related to operation of
NINE MILE POINT NUCLEAR STATION
UNIT 1

DOCKET NO. 50-220

JANUARY 1974

REGULATORY DOCKET FILE COPY
UNITED STATES ATOMIC ENERGY COMMISSION
DIRECTORATE OF LICENSING

FIG. 3.9. UPGRADED LIQUID RADWASTE SYSTEM,
NINE MILE POINT NUCLEAR STATION, UNIT 1.

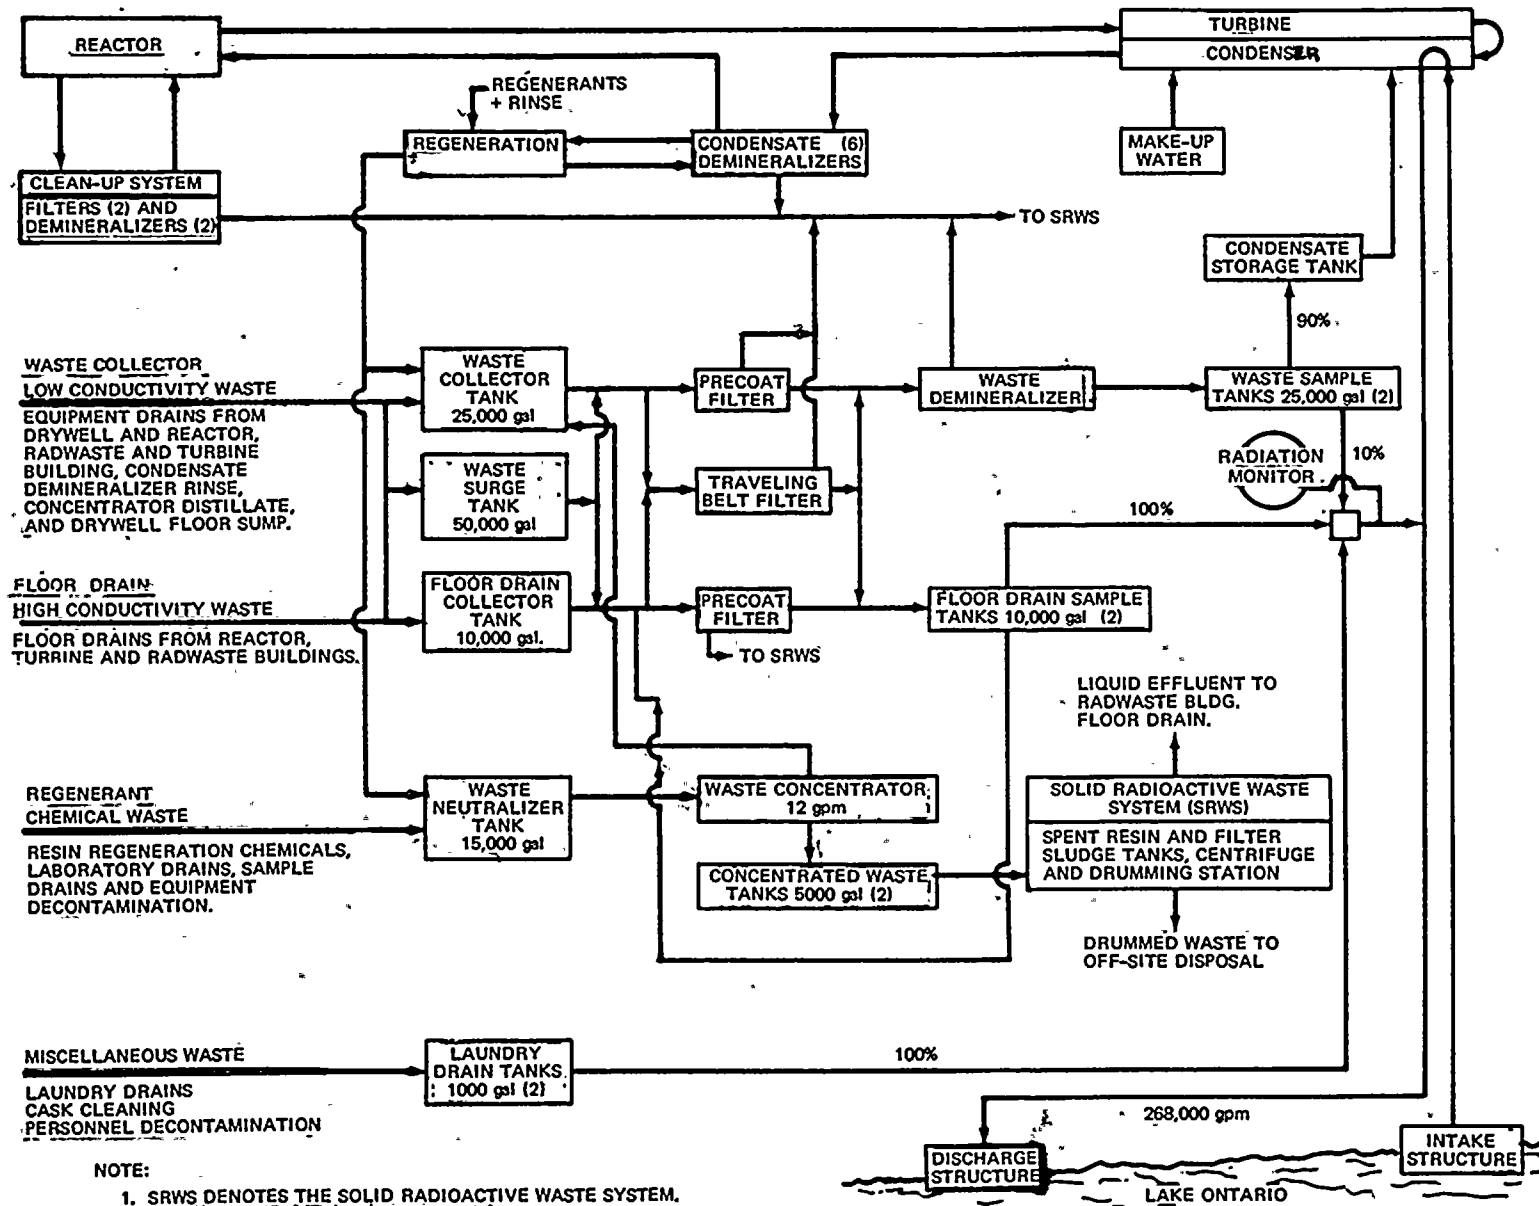
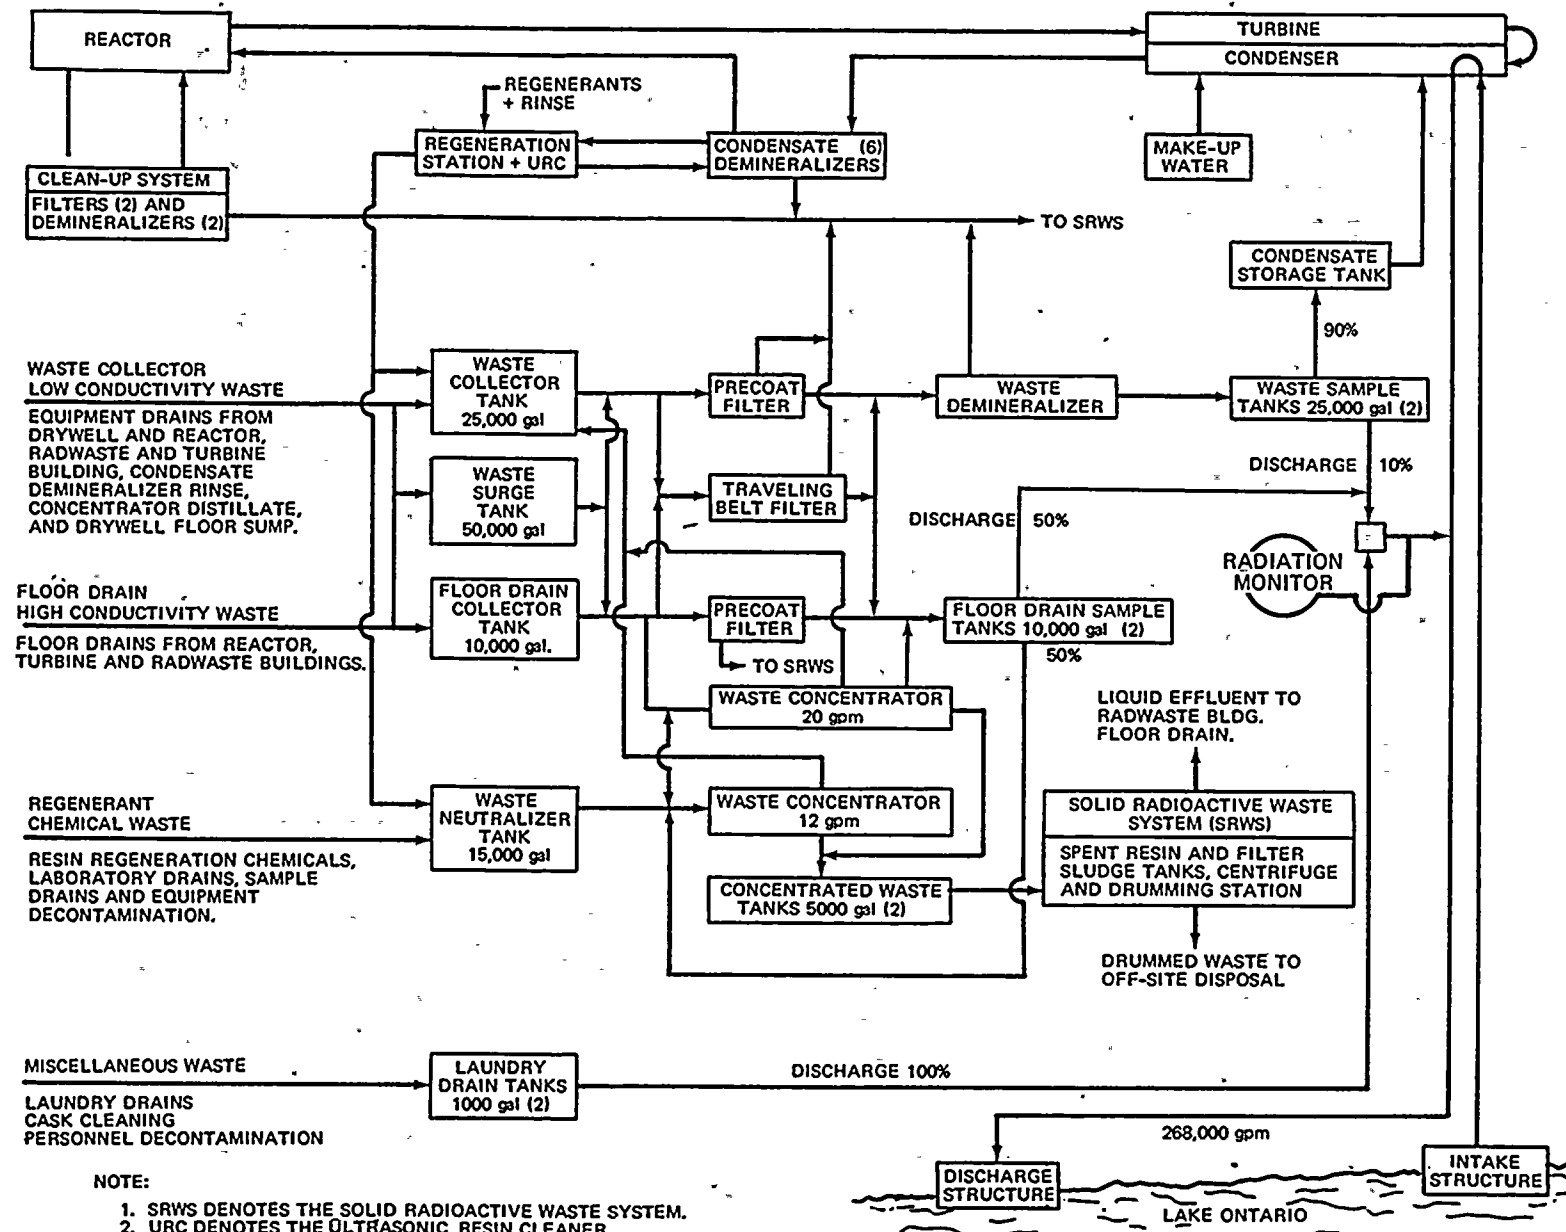
The diagrams (Fig. 3.8 and 3.9) are correct in that about 10 percent of the Waste collector low conductivity, low activity waste is discharged as an excess. The diagrams are incorrect in that Figure 3.9 does not show a discharge from the floor drain sample tanks to discharge. This discharge is 2,700 gal. per day as delineated in the Environmental Report.
